Warehousing / Logistics, Office, and Cafe / Restaurant Development at Calmount Road

Engineers Responce to Clarification of Further
Information Request

210175-DBFL-TR-XX-RP-C-0005

Figure 3.1 : Alignment Options for SDCC Roads Objective (Calmount Rd and Ballymount Rd Lwr)

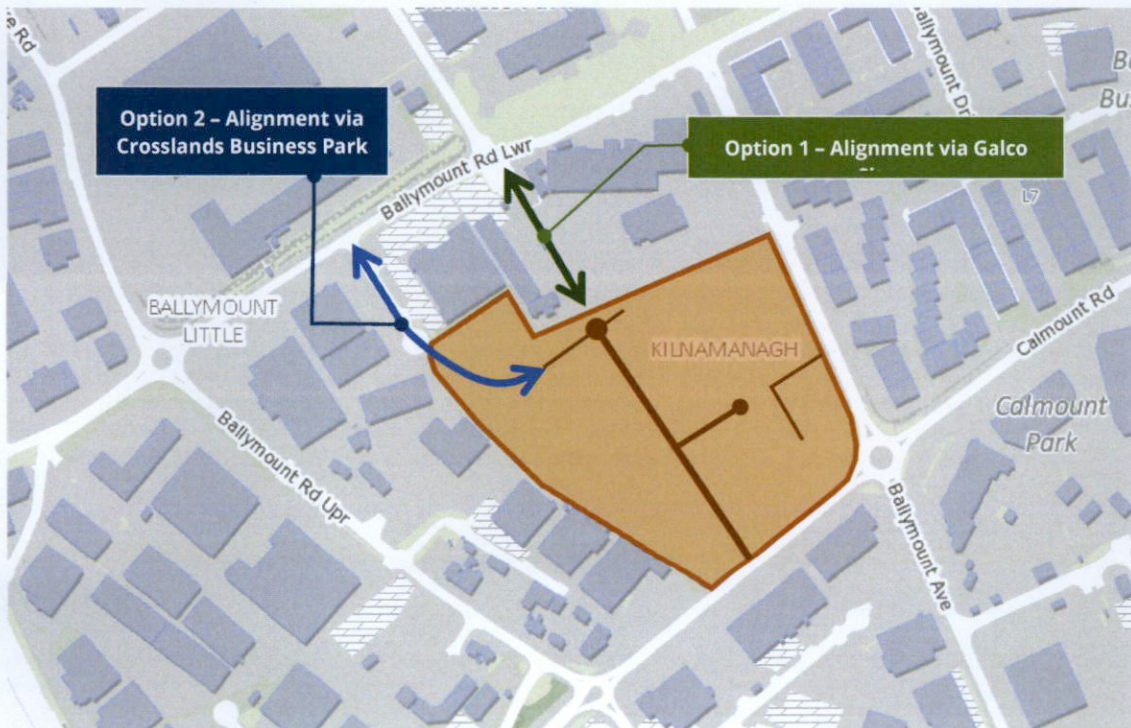
The Forward Planning team has expressed concerns regarding the proposed road layout stating that it could be premature and that the applicant should further examine the potential to arrange unit 2 so as not to preclude the future realignment of this road."

- A reduction in the size of Unit 2 and rearranging its orientation. The main entrance, office accommodation and associated facade treatments have been positioned within the North East corner of the Unit 2 building. In this way the offices will face onto the proposed North-South spine road (in its current configuration) and the service road leading to/from the Unit 2 marshalling yard (potential interim arrangement with future upgrade facilitating its function as a western connection option to Ballymount Road Lower).

This new layout retains the flexibility to provide not one but two potential options for the future completion of SDCC's roads objective between Calmount Rd and Ballymount Road Lower as illustrated in Figure 3.1. With the new full sized continental roundabout provided in the updated layout, the final connecting road link to Ballymount Road Lower (by others in the future) can be accommodated by the amended scheme proposals by either (or both);

- **Option 1** - Northwards through the Galco lands, in keeping with the SDCC zoning map 5 objective, or
- **Option 2** - Westwards along the northern boundary of the reoriented Unit 2 plot before turning north-westwards to connect to the existing Crosslands Business Park cul de sac.

Figure 4.1: NTA's 2022 CBC Proposals at Calmount Rd / Ballymount Avenue Junction

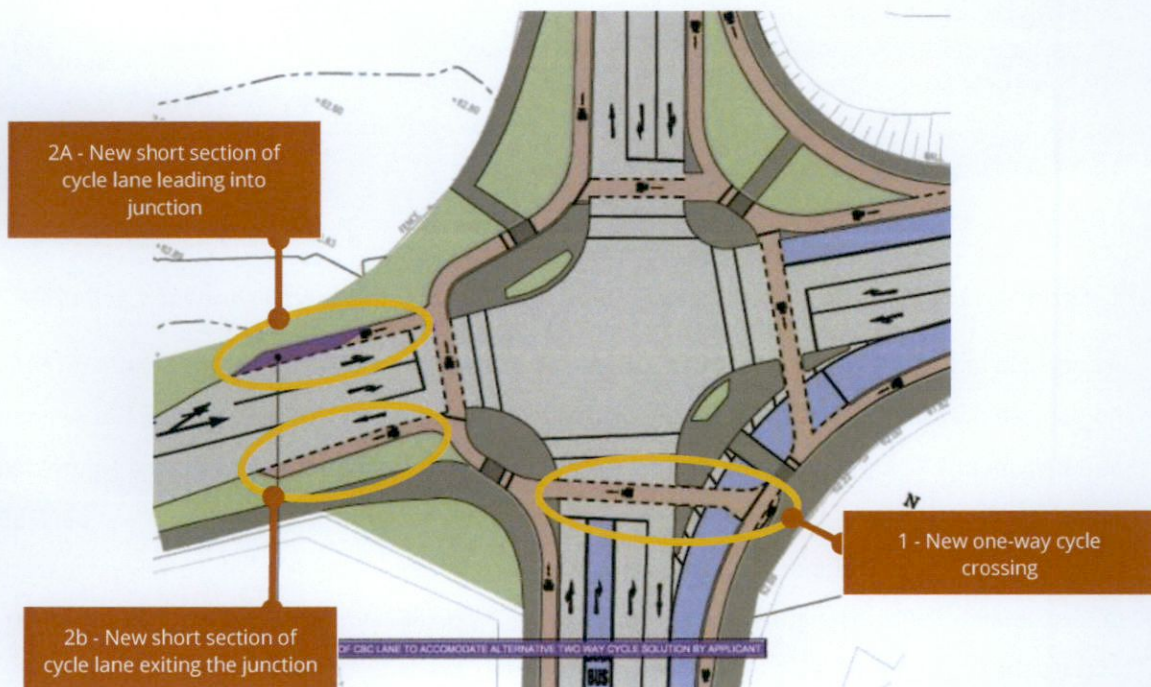
The applicant is requested to provide revised proposals on proposed cycle tracks and proposed shared pedestrian/cycle areas including tactile paving crossing points at the south-east corner of the application site with a view to resolving the interface between the proposed development and the NTA's Greenhills to City Centre Core Bus Corridor particularly the upgrade to the junction between Calmount Road and Ballymount Avenue. The applicant is requested to take the following into consideration:

- the Emerging Preferred Bus Connects Route*
- There is a proposed 2-way cycle track indicated on Calmount Road, western side of junction-BusConnects provides a tie-in on western side of junction for single cycle provision either side of road.*

The latest NTA CBC proposals along Calmount Road corridor very much respect the same configuration (conversion of existing roundabout junction to a signal controlled layout) as previously proposed and disseminated during the 2020 public consultation exercise (as

- 1) New westbound cycle crossing provided on the junction's southern arm, and
- 2) Provision of one-way cycle transfer facilities to enable cyclists enter and exit the junctions segregated cycle tracks when traveling to and from Calmount Road West (western arm of the junction) carriageway.

Figure 4.2: Local Off-Site Bicycle Infrastructure (Existing and Proposed by Applicant and CBC)

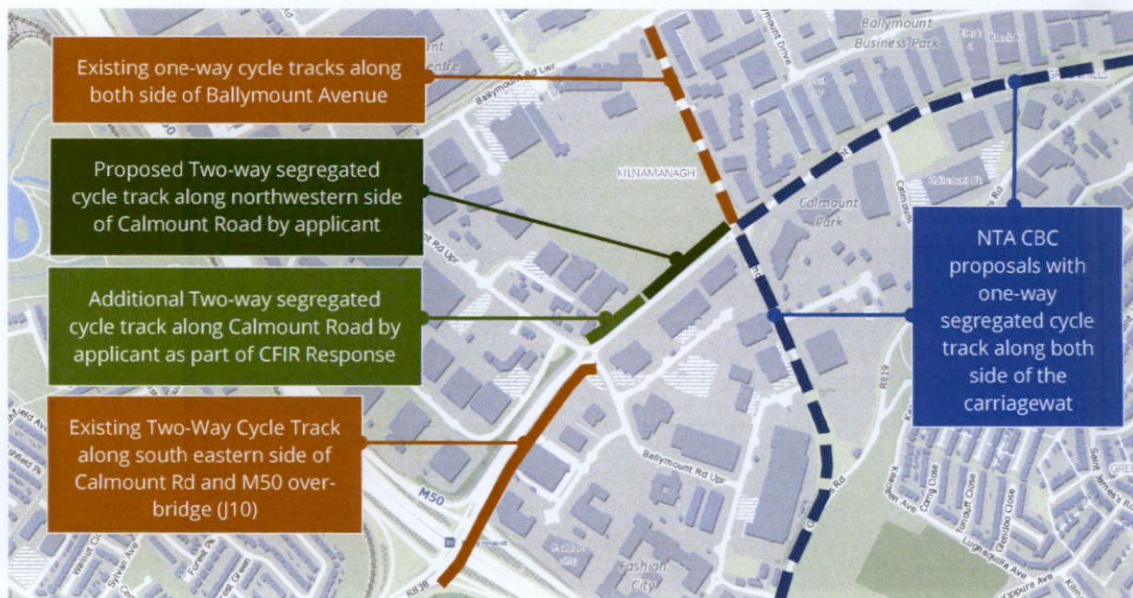
Proposed development north-west cycle track does not match BusConnects proposal where a footpath is proposed at boundary to proposed development.

As detailed in the original planning application and subsequent FIR response there are currently no dedicated cycle facilities along the site frontage on Calmount Rd between Ballymount Avenue and Ballymount Rd Upper. Responding to the existing two-way cycle track (reference Figure 4.2) provided along Calmount Rd (south eastern side only) between Ballymount Rd Upper and the M50 (including the J10 overbridge) the applicant included the implementation of a two-way cycle track (approximately 190m in length) along the north western side of Calmount Rd over the entire length of the subject site frontage.

As part of this CFIR response the applicant is now demonstrating how this two-way cycle track south-eastwards could be extended if considered necessary by the planning authority by a further 110m to connect with the Ballymount Rd Upper / Calmount Rd junction. The updated CFIR scheme proposals for the off-site active travel works along Calmount Road corridor are detailed in Figure 4.3 below and in DBFL drawings 210175-DBFL-RD-SP-DR-C-1101 (potential Short Term scenario e.g. prior to CBC junction works) and 210175-DBFL-TR-SP-DR-C-1121 (medium term scenario with
